ACCESS DESIGN REVIEW – DEVELOPMENT APPLICATION (DA)

12-16 Bent Street, Lindfield NSW

Project number: 116856

Revision: 4.1

Level 01 - Accessways

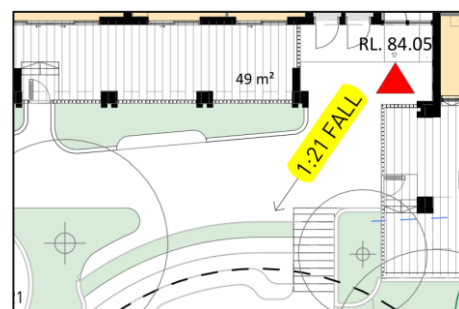
1. For the proposed accessways noted in **Part 3.9.2** of this report, consider the following technical provisions of AS1428.1-2021 related to walkways and landings to satisfy compliance and ensure that they can be addressed as the design progresses:

- **1:20** walkways require landings at intervals no greater than **15m** in line with Clause 7.2(b)(ii) of AS1428.1-2021.
- **1:22** walkways require landings at intervals no greater than **16.54mm** in line with Clause 7.2(b)(iii) of AS1428.1-2021.

- The walkways shall comply with Clause 7.4 for curved walkways and Clause 4.2 of AS1428.1-2021 for the abutment of the sides.
- Landings (on a 1:40 gradient) shall be provided at all changes in direction in accordance with Clause 7.8 of AS1428.1-221 which requires **1200mm** (Figure 25 (A) in length where there is no change in direction, **1500mm** (Figure 25(B) where there is a change of direction not exceeding 90 degrees and for a 180 degree turn, the landing shall be as shown in Figure 25(C).

- A turning space complying with AS1428.1-2021 (1540mm wide x 2070mm long) is required at maximum 20m intervals along the accessways (walkway) as per D4D4(c)(ii)(B) of the BCA.

- A passing space complying with AS1428.1-2021(1800mm x 2000mm) is required at maximum 20m intervals on those parts of an accessway where a direct line of sight is not available.

Level 01 – General communications stairway

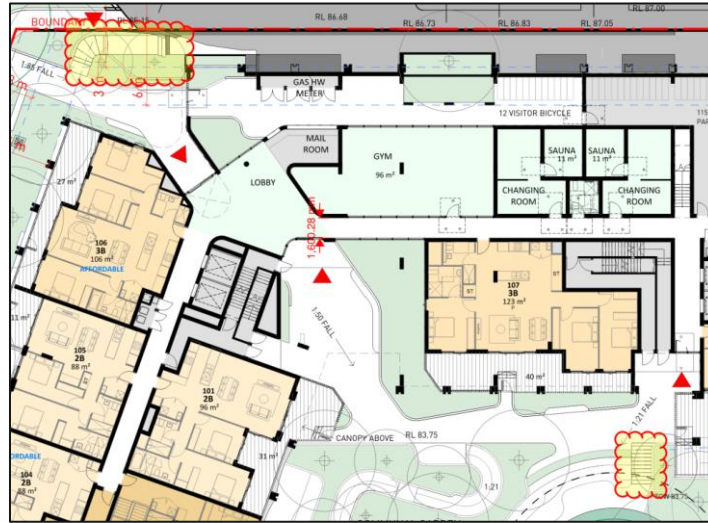
2. The general communication stairway noted on Level 01 (serving the communal garden) and the stairway serving the secondary access points to the SOUs is to provide dual handrails, 1m clear width between handrails, extensions/terminations as per AS1428.1-2021 and TGSIs as per AS14284.1-2009. This is capable of being addressed post-DA, however, is to be considered by the design team as the design progresses.
